**Town of Londonderry Planning Board  
268B Mammoth Road - Moose Hill Conference  
Agenda  
February 4, 2026  
7:00 p.m.**

- A. Public hearing for an application for formal review of a site plan for forty (40) residential units and a conditional use permit for 1,023 square feet of buffer impacts, including associated site improvements in the Commercial II (C-II) Zone. 225 Rockingham Road, Tax Map 15, Lot 126, Genex Construction Group, LLC (Owner/Applicant).

- C. Public hearing for an application for formal review of a site plan for a 48-unit multi-family residential development and a conditional use permit for 2,808 square feet of wetland impacts and 2,357 square feet of buffer impacts, including associated site improvements in the Commercial 1 (C-1) District. 222 Rockingham Road, Tax Map 15, Lot 150-1, Dark Horse Investments, LLC (Owner/Applicant).

SHEET 13 of 24

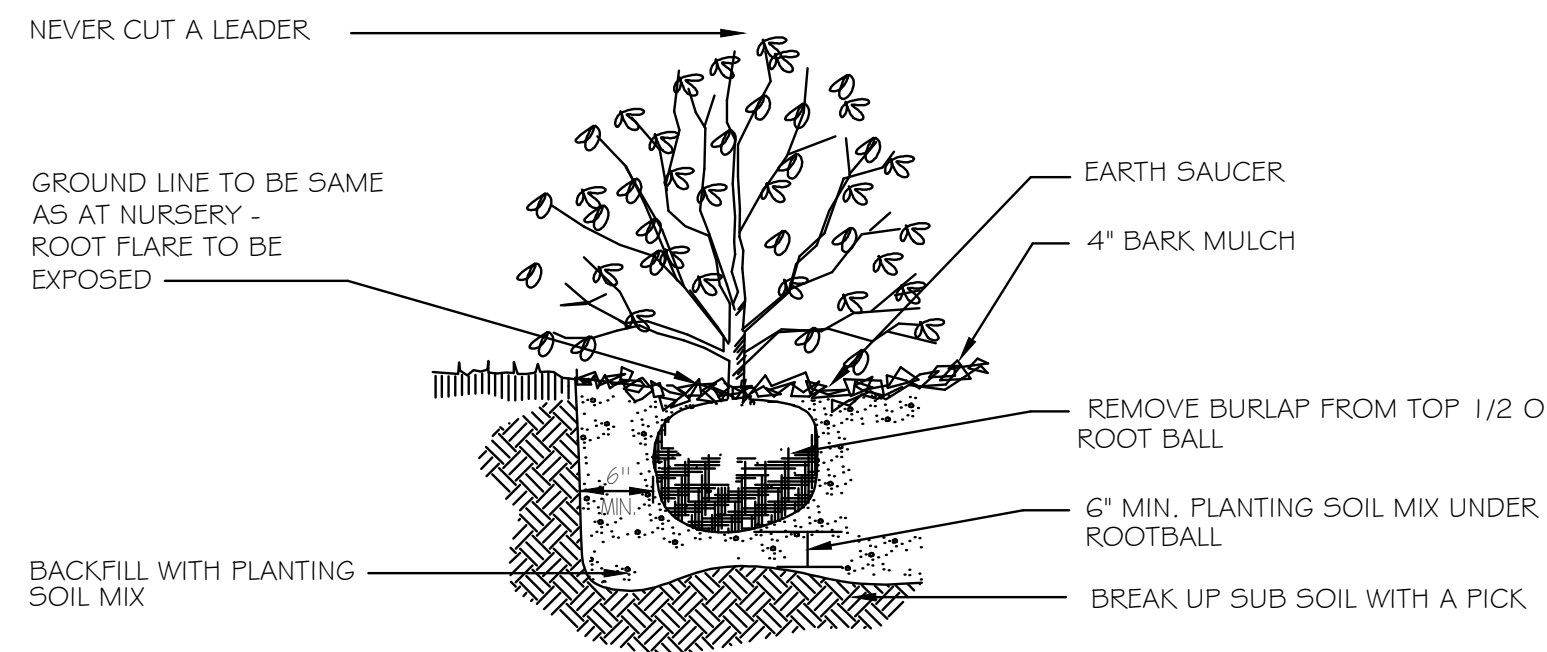
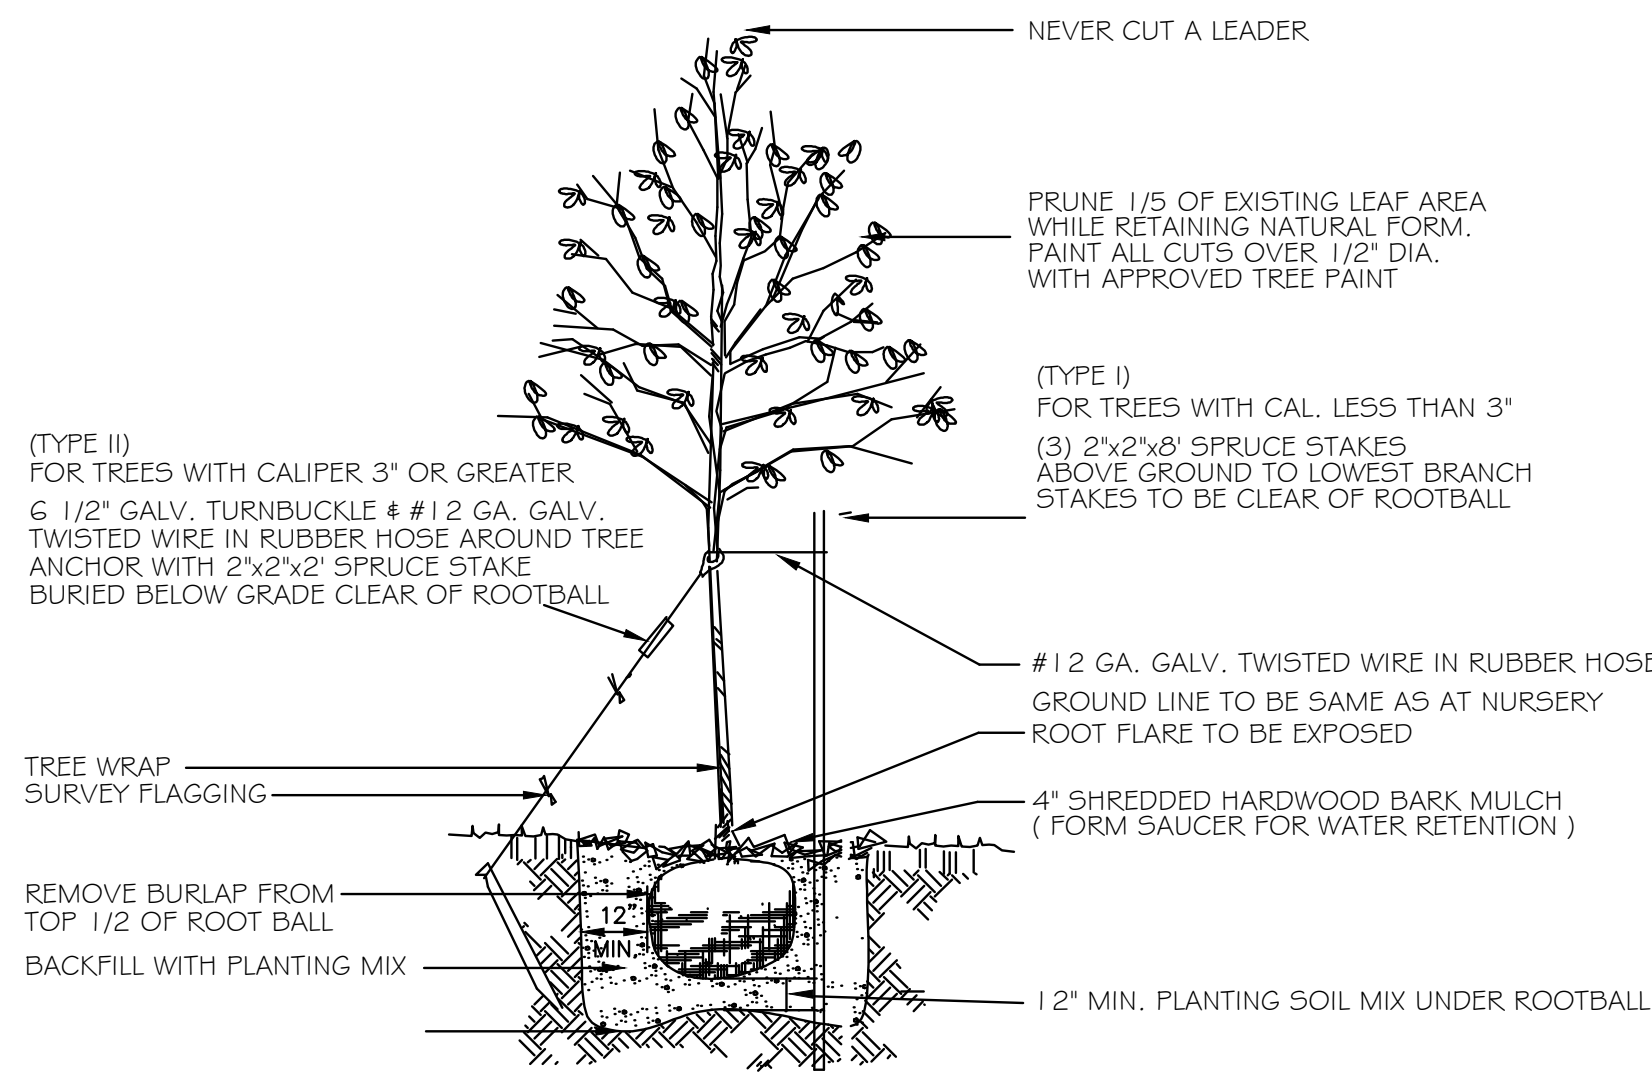
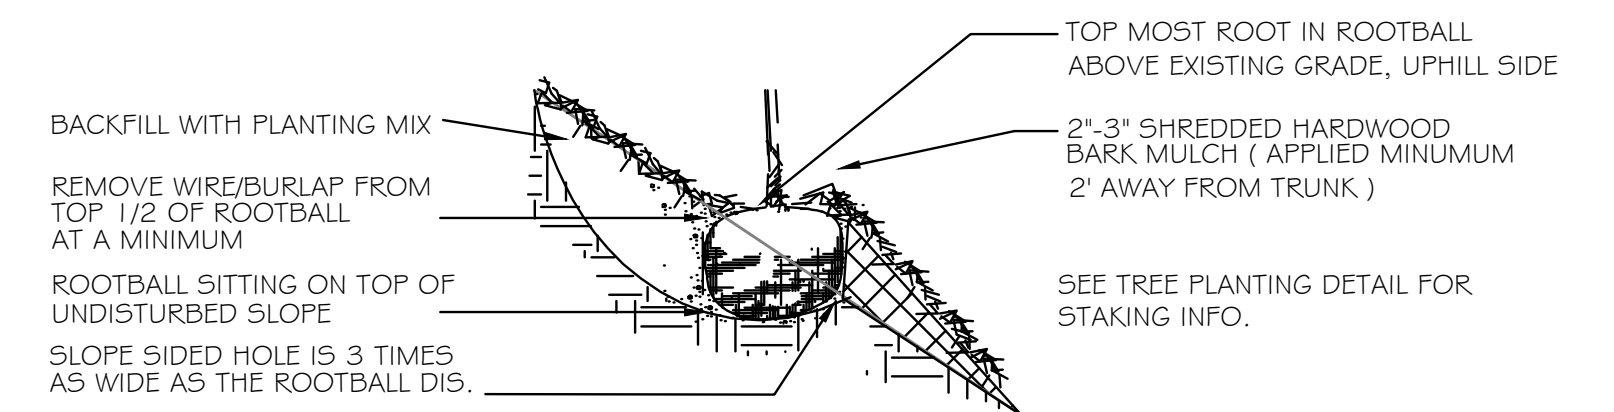
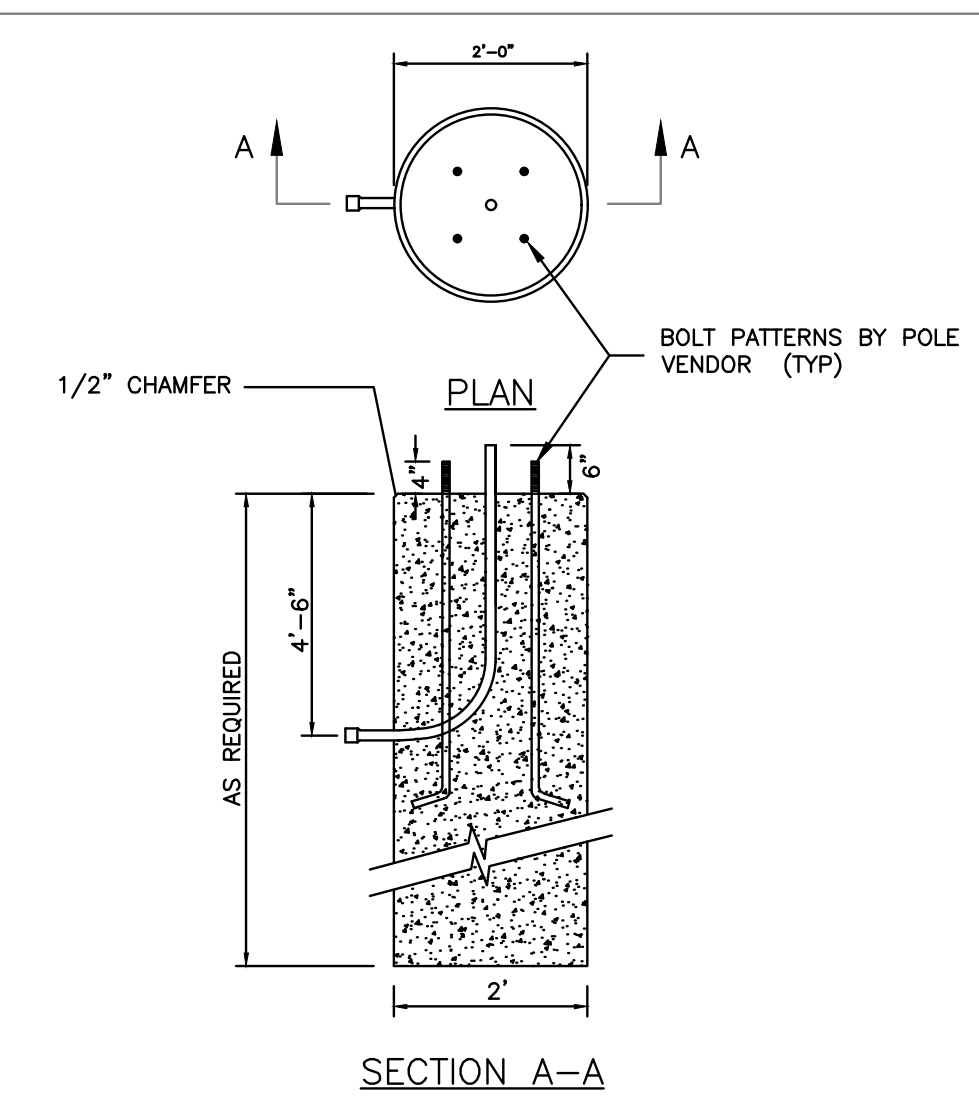
- l. Please remove the Planning Board signature block from the Landscape details - sheet 13 - per section 4.03 of the regulations.
